Service Bulletin

Date MAY 1984
Sheet 1 of 2
Bulletin JD.05/84

XJ-S/XJ-SC

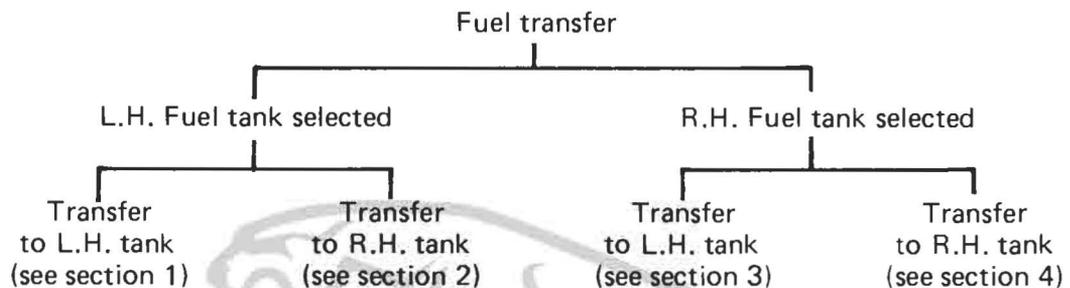
Revised changeover solenoid valves were introduced on Jaguar Production at VIN 370660, and revised recirculation valves were introduced at VIN 384100.

New Part No.	Old Part No.
Fuel changeover solenoid	CAC 8000	CAC 3941
R.H. Fuel recirculation valve	CAC 8346	CAC 3988

FIG 3

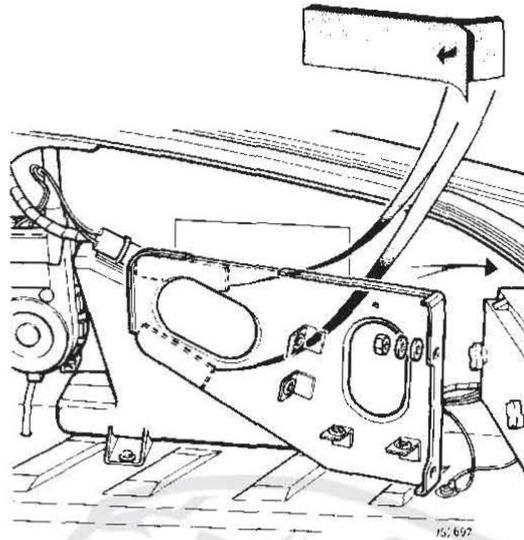
- 3) Should a rattle be suspected between the module mounting bracket and the rear wing, fit two self-adhesive foam pads to the bracket rear face (Fig.3).

FIG 4

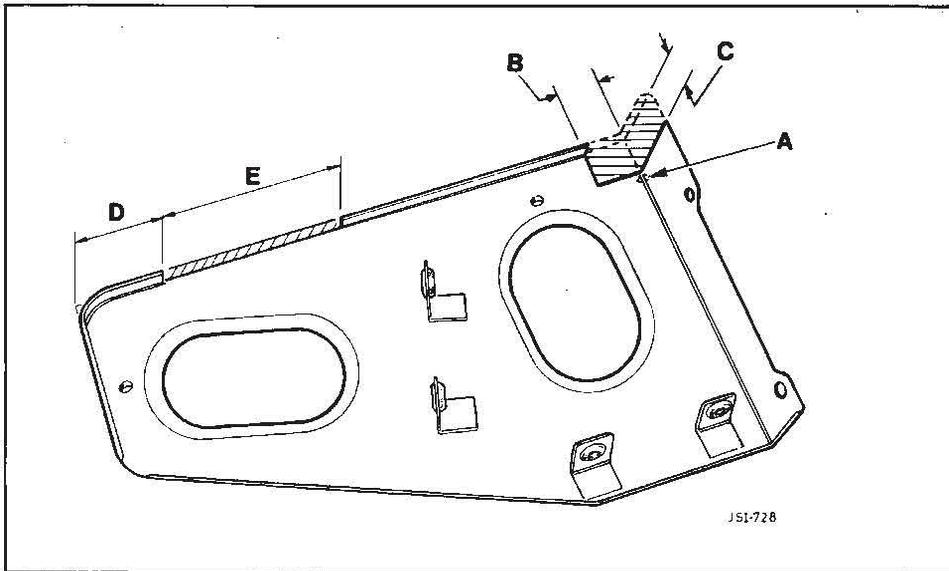
- 1) On certain vehicles the module mounting bracket top rear corner may make contact with the vehicle rear wing.
- 2) Before securing the bracket, place it in position to check the clearance at this point. If the bracket touches the wing, remove the corner section as shown in Fig.4; dimensions 'B' and 'C' are 15 mm (0.6 in).

1. In place of the supplied module securing bolt, substitute a longer (M6 x 19 mm) bolt used in conjunction with a 7 mm spacer (not supplied).
2. Alternatively, remove a flange section to the dimensions referred to on Fig.4, where 'D' = 50 mm (2 in.) and 'E' = 100 mm (4 in).

FIG 4

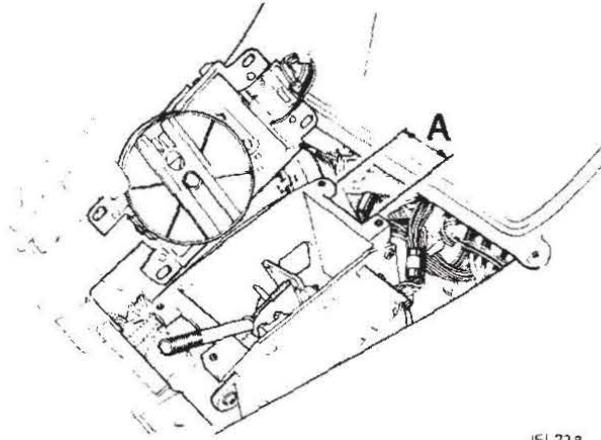
NOTE: On early cars it may be necessary to relieve (stretch) the J-gate housing Fig 4A to ensure the correct position is achieved.

Fig. 1.

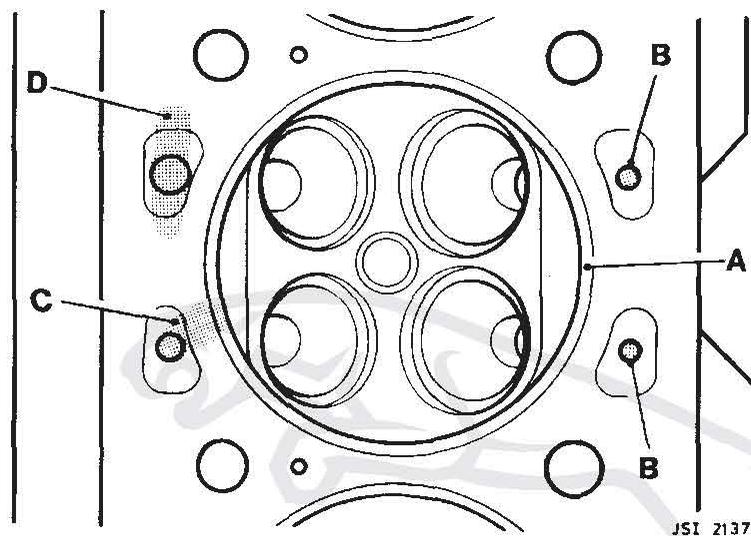
On engines prior to VIN 677386 (XJ6) and VIN 187554 (XJS) the foundry practices involved in the manufacture of the cylinder head and the cylinder block resulted in elongated cored coolant passages at the upper face of the cylinder block, facing small diameter drilled passages in the cylinder head, separated by the gasket. Coolant flow between cylinder block and cylinder head is controlled by the diameter of the holes in the cylinder head gasket (Item B, Fig. 1.)

Provided that the eroded area (condition C, Fig.1.) does NOT extend into the area occupied by any firing ring, (Item 'A', Fig 1.), of the head gasket, using a head gasket as a template; a repair can be effected and there is no need to replace the cylinder head.
